**SERVICE BULLETIN**

**BULLETIN NUMBER:** SB011

**SUBJECT:** Control column torque tube cracks

**APPLICABILITY:** All KFA aircraft

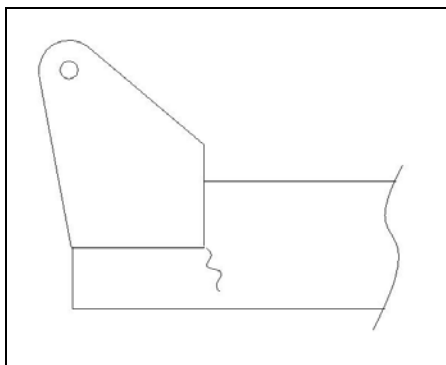
**Problem:** Cracks have been found on two occasions on the FCC control column torque tube, left rear side.

**Solution:** Remove the blue bearing block and inspect torque tube for cracks at every 100 hour or annual inspection.  
If any cracks are found, send the part back to KFA for replacement or repair.
